Request to Modify John Kimbrough Blvd. Pickard Pass

Clint Willis, Manager
Transportation Services
CBE Design Review Committee Meeting
Oct. 28, 2020

TEXAS A&M UNIVERSITY

SOUTH FACE - DEMOLITION PLAN

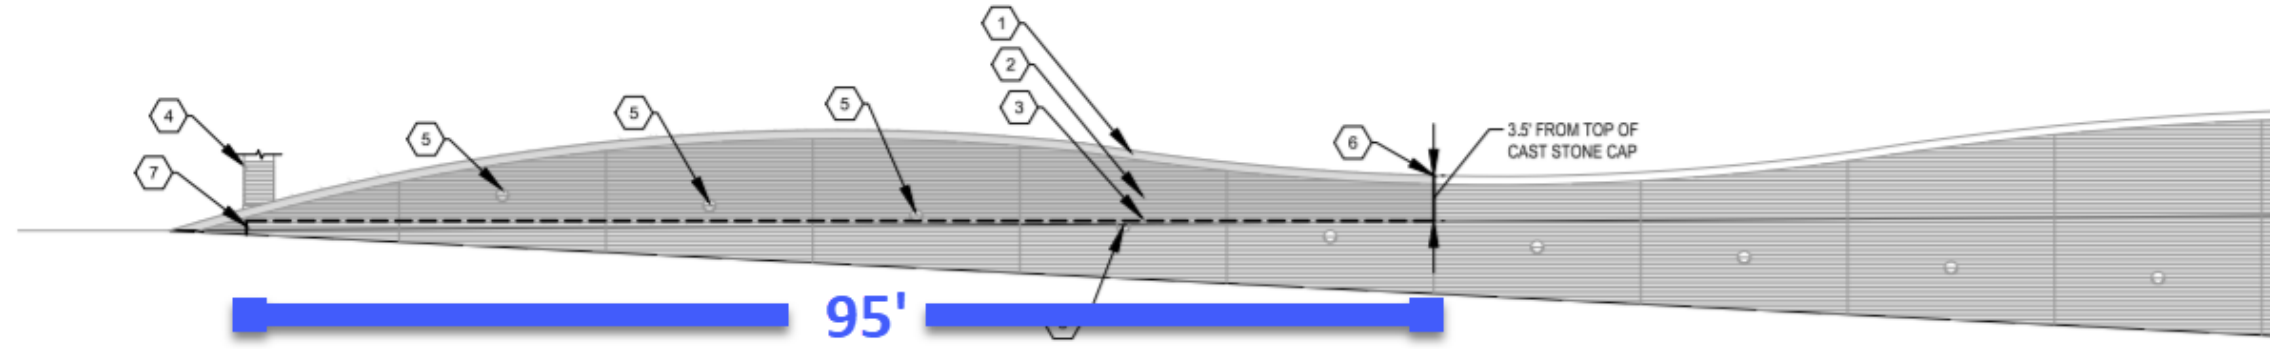
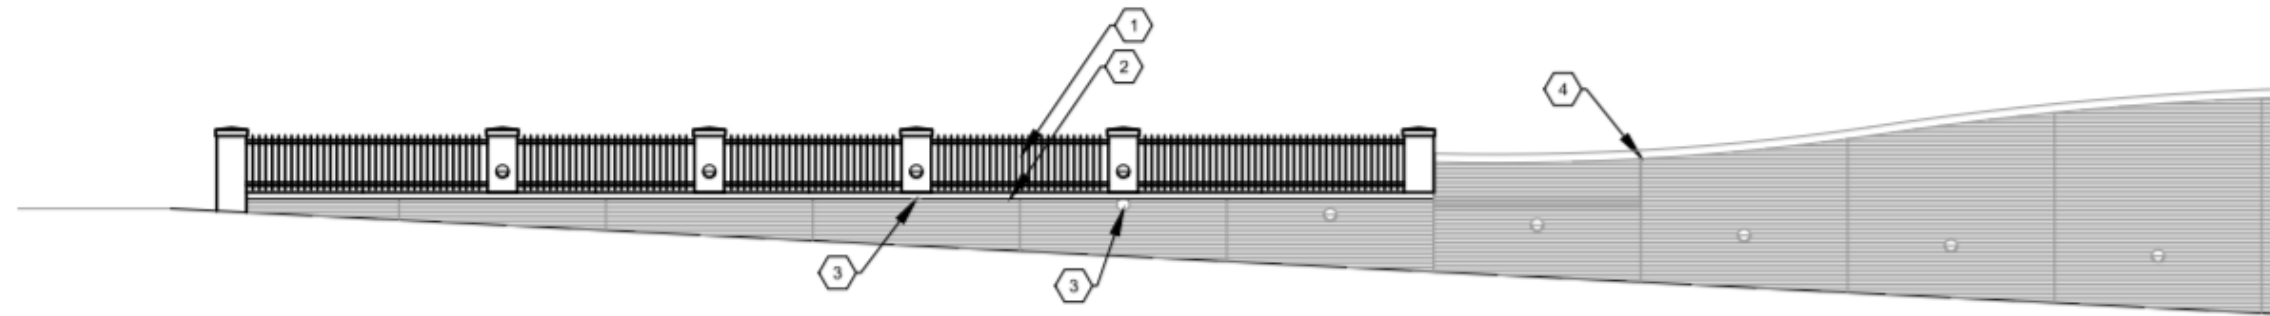
West End of Passageway

Lot 61 Fence

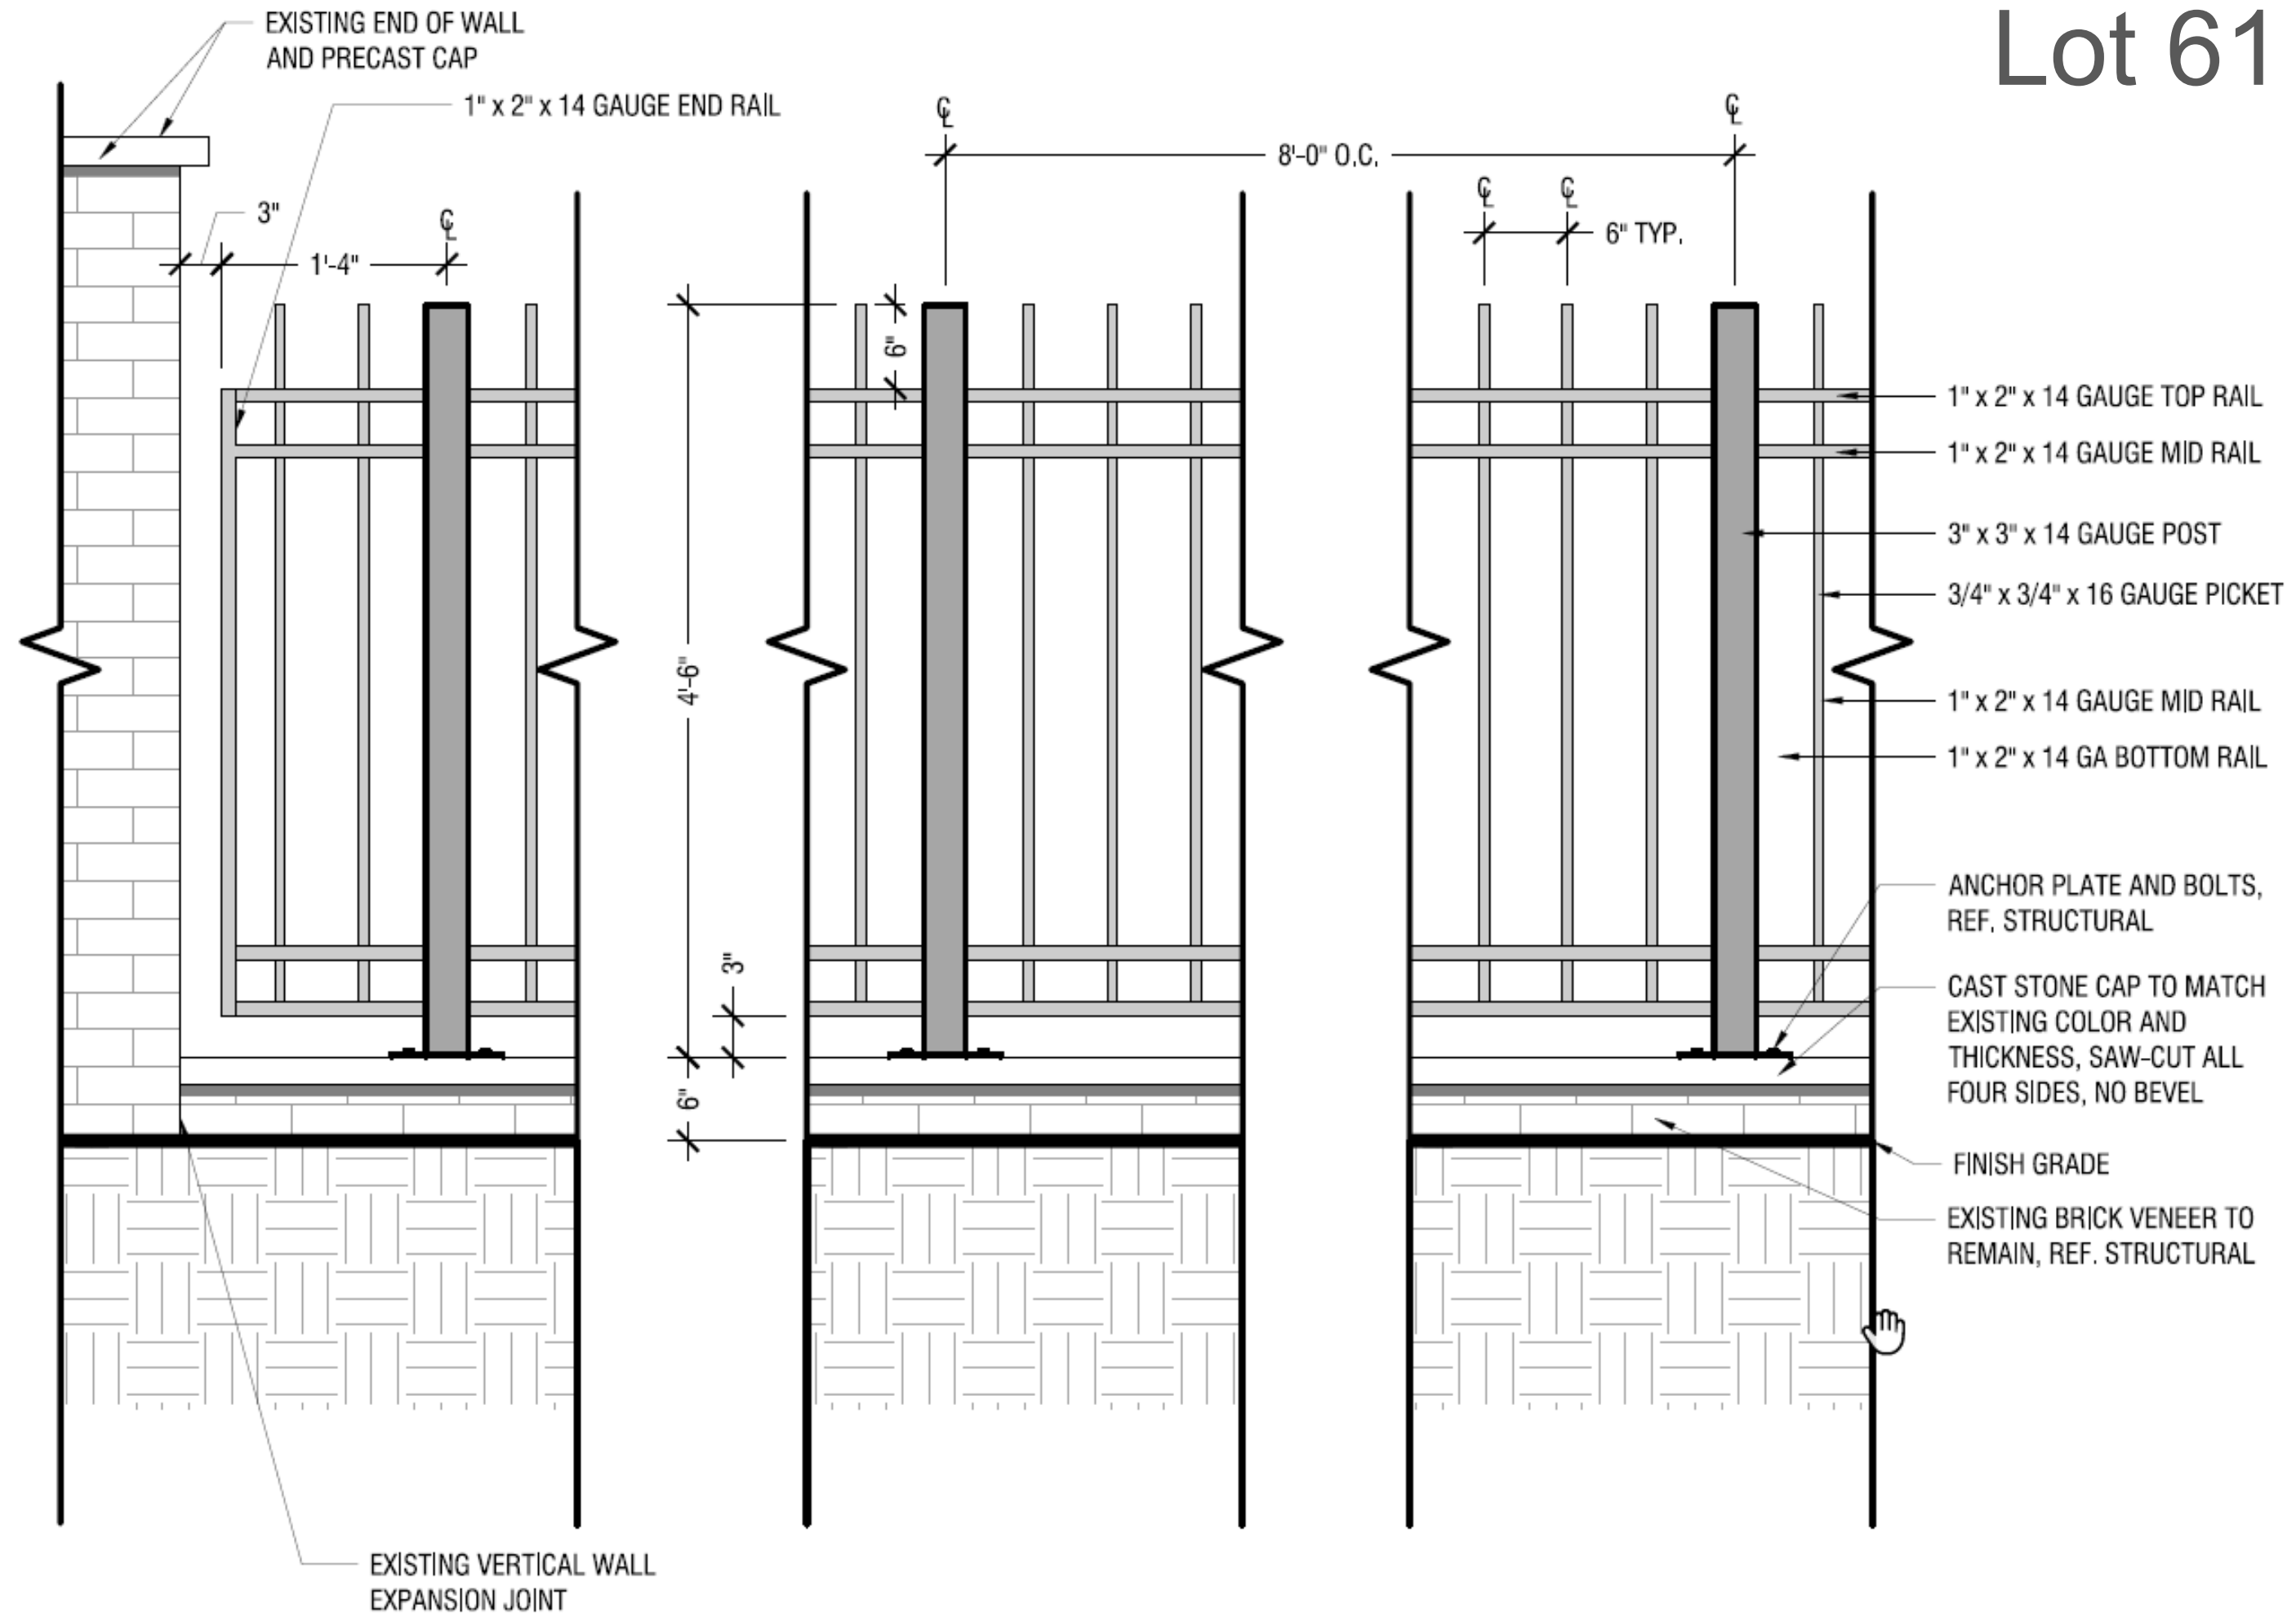
Sidewalks to Wellborn Rd. eliminated;
fence and landscaping added

New fence at Lot 61 will be brick and iron fence like Lot 62 along Wellborn Rd.

JOHN KIMBROUGH BOULEVARD

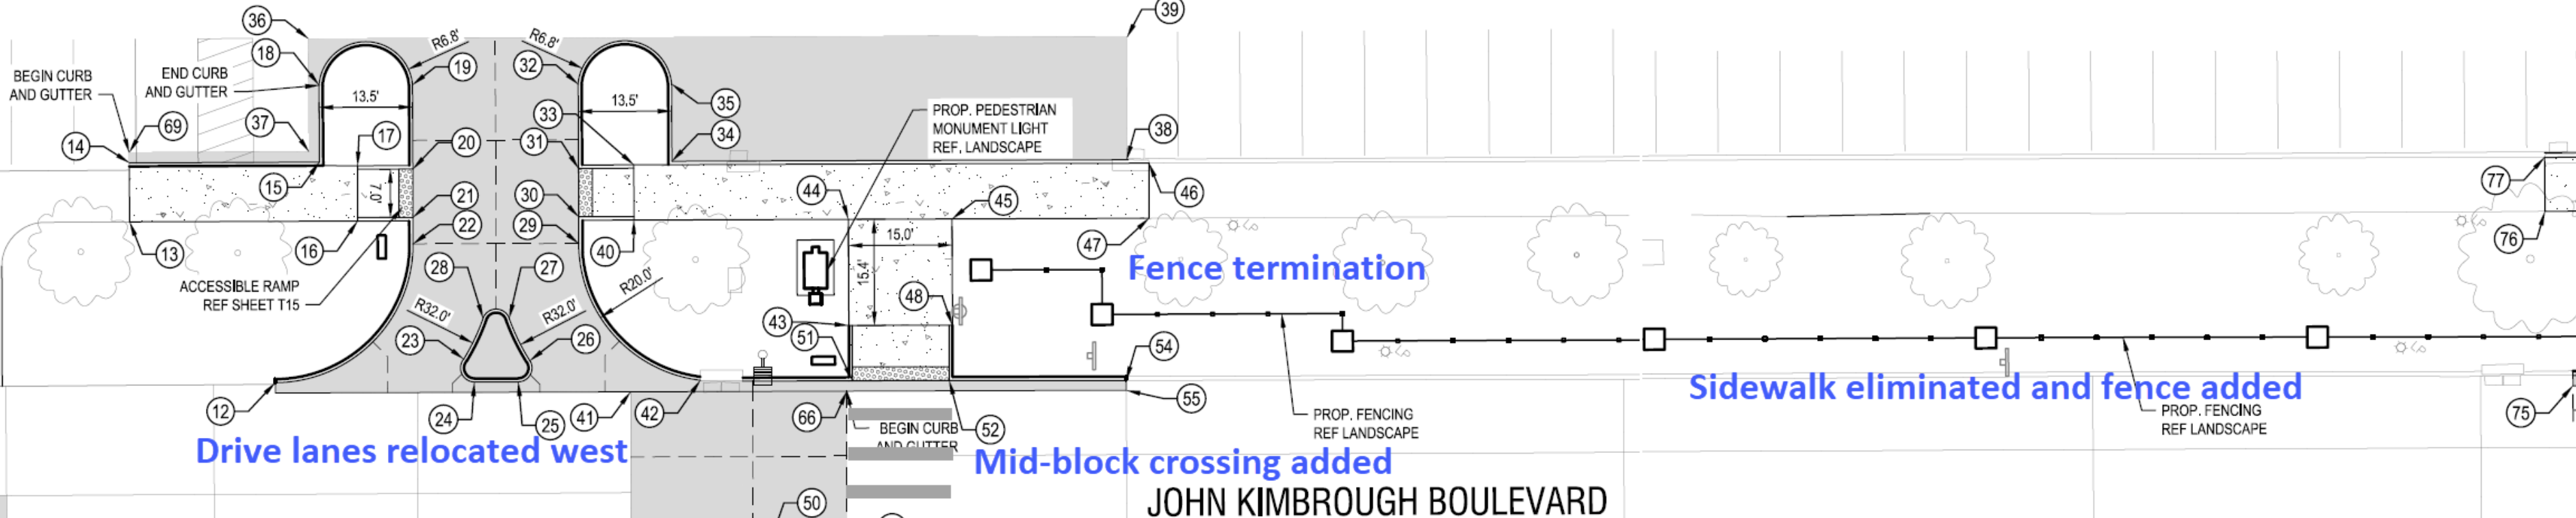
**Relocated drive lanes at Lot 61
align with drive lane within the lot**
